ADDENDUM NO. CC-2

STATE OF NEBRASKA  
TSB – EXTERIOR RENOVATION  
LINCOLN, NEBRASKA  
DLR GROUP PROJECT NO. 10-09206-30

September 13, 2012

NOTICE TO BIDDERS: Amend the Project Manual and Drawings to the above referenced project as follows:

# TUCKPOINTING DETAIL (TYP.)

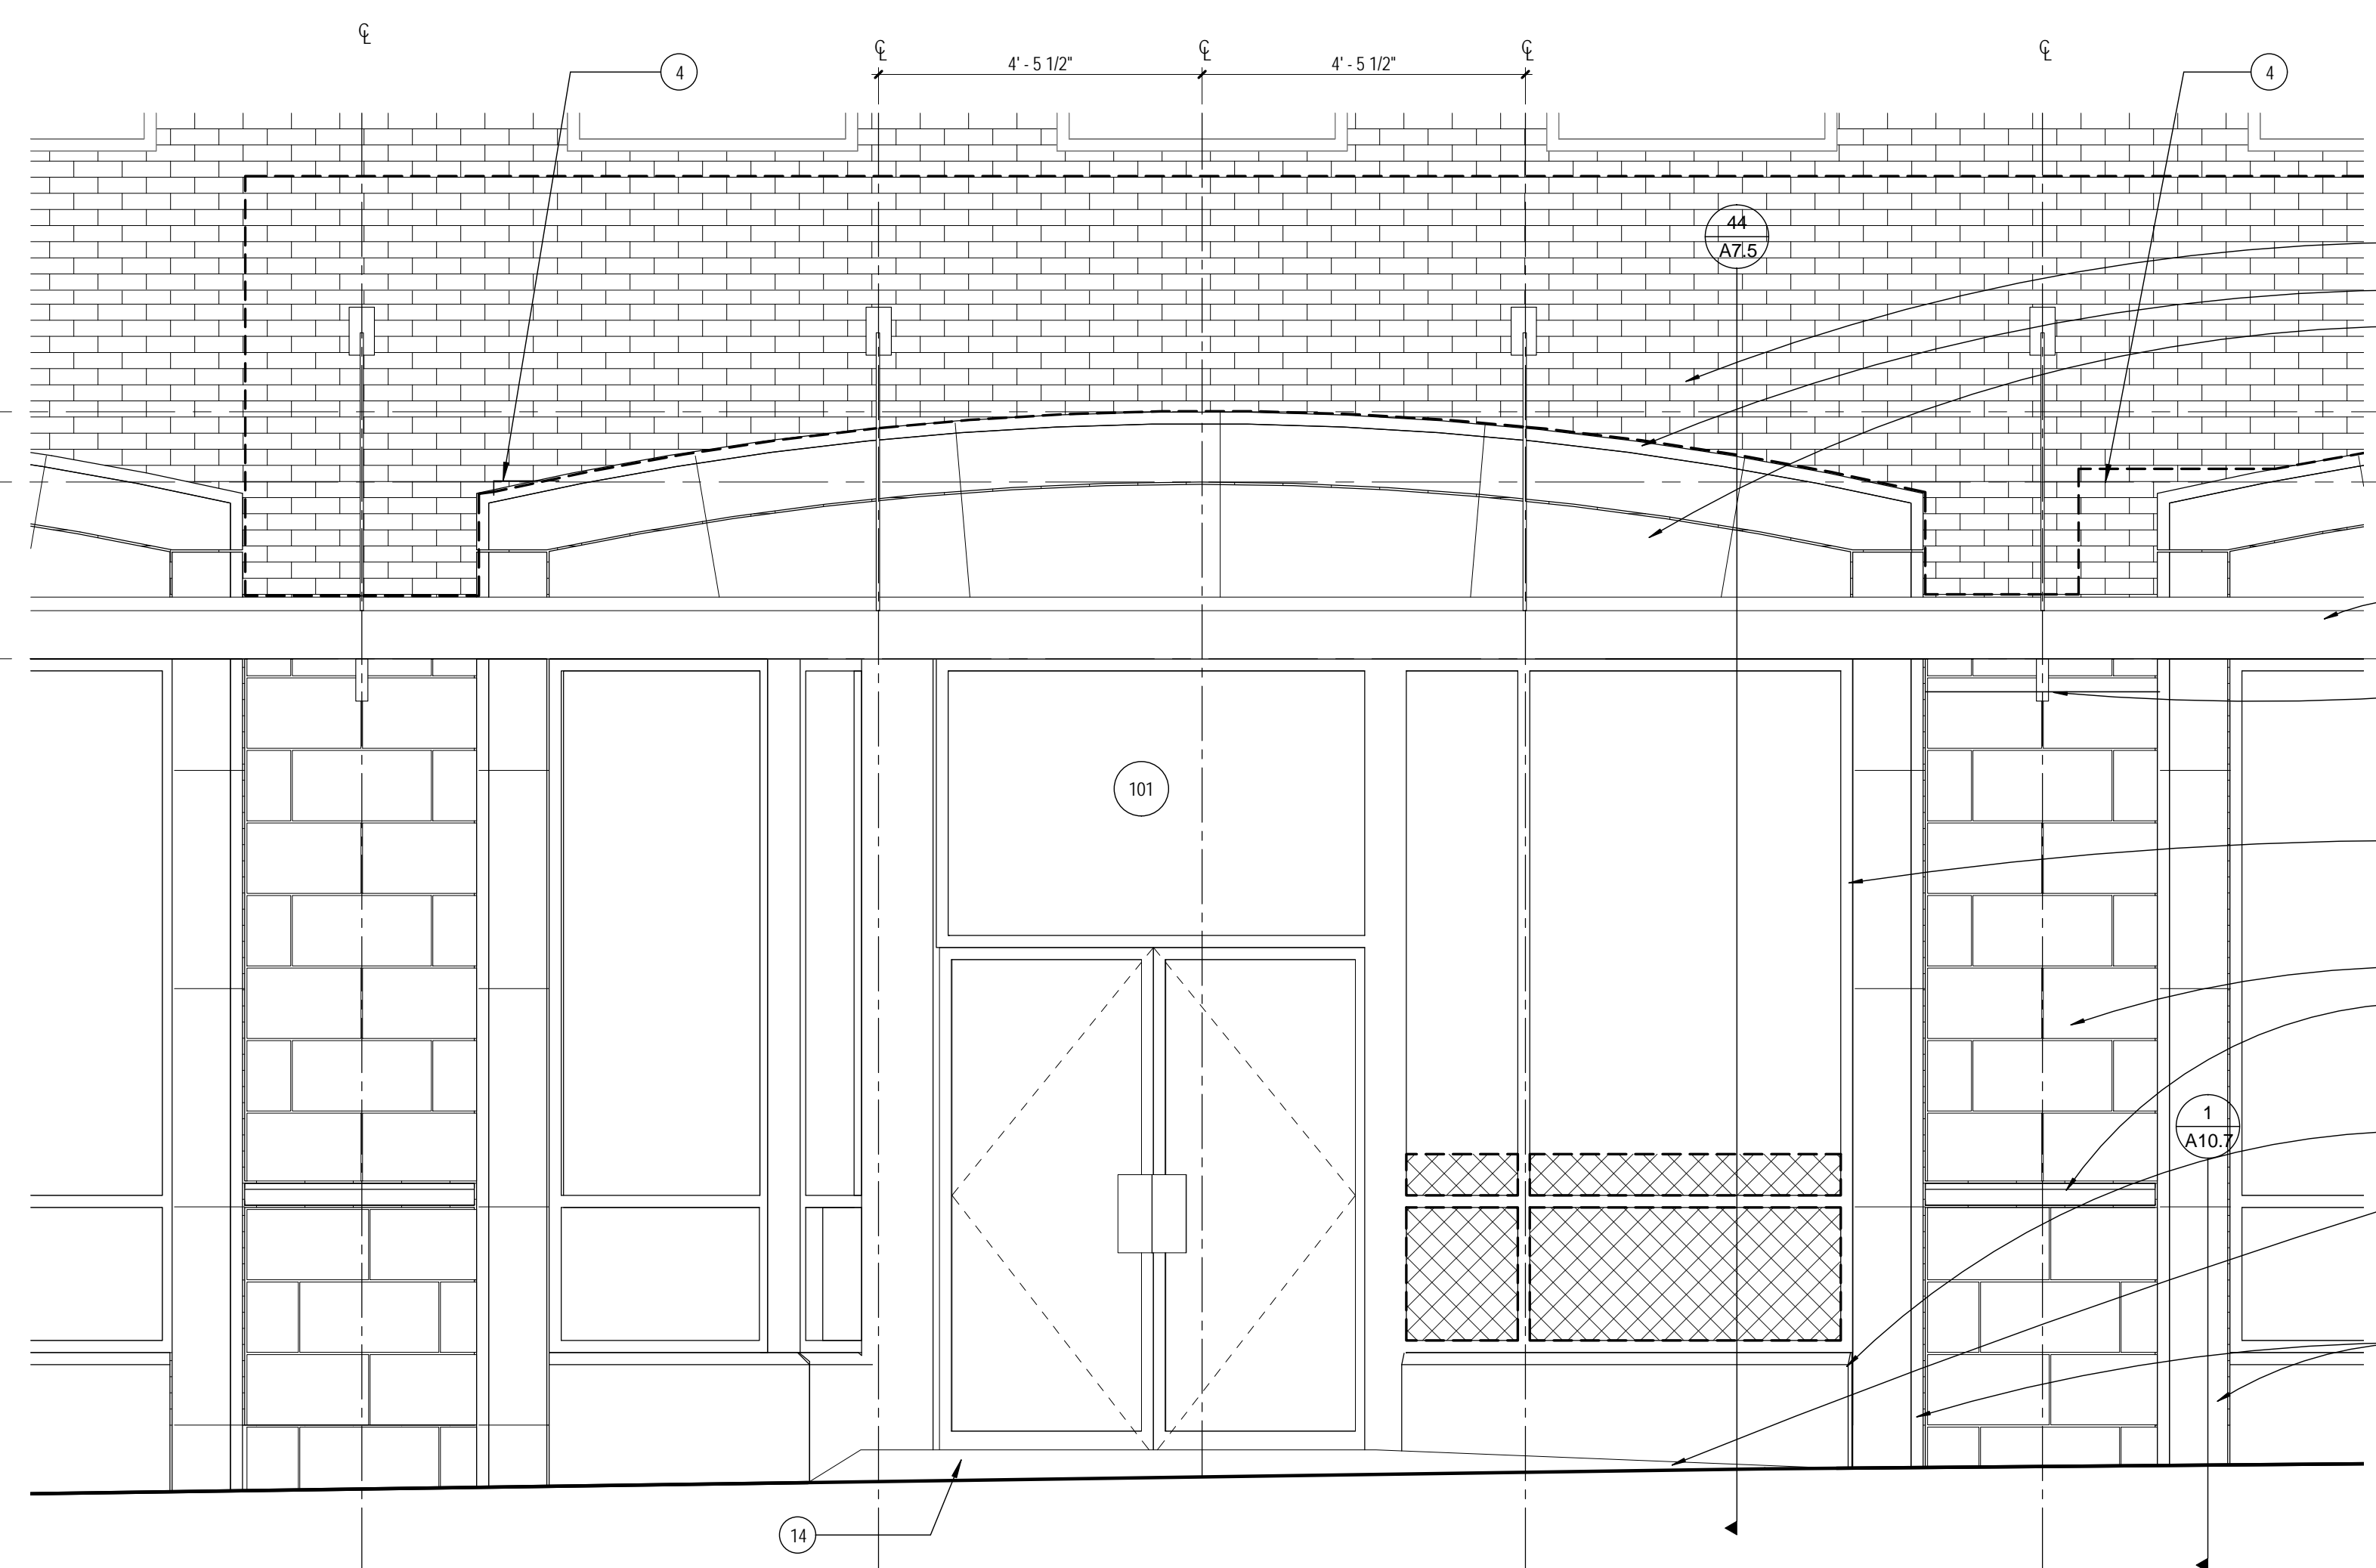
ITEM NO. 8 DRAWING A10.11 - TUCKPOINTING DETAIL

A. Add Drawing A10.11, Attachment No. 11 to the documents.

EXISTING SOUND MORTAR TO REMAIN.  
NEW JOINT PROFILE TO MATCH ORIGINAL. NEW MORTAR SHALL NOT EXTEND BEYOND EDGE OF MASONRY.  
GRIND JOINT APPROX 1 1/2" MIN. OR CONTINUE TO SOUND MORTAR.  
CLEAN JOINT AND POINT WITH NEW SELECTED POINTING MORTAR.  
DO NOT CHIP OR DAMAGE EXISTING MASONRY WHEN REMOVING MORTAR FROM JOINT.  
GRIND ALL HEAD JOINTS SIMILAR TO BED JOINTS.

OVERCUTS INTO MASONRY JOINTS OR SAWCUTS SURFACE OF MASONRY UNACCEPTABLE -- MATERIAL REPLACED AT NO COST
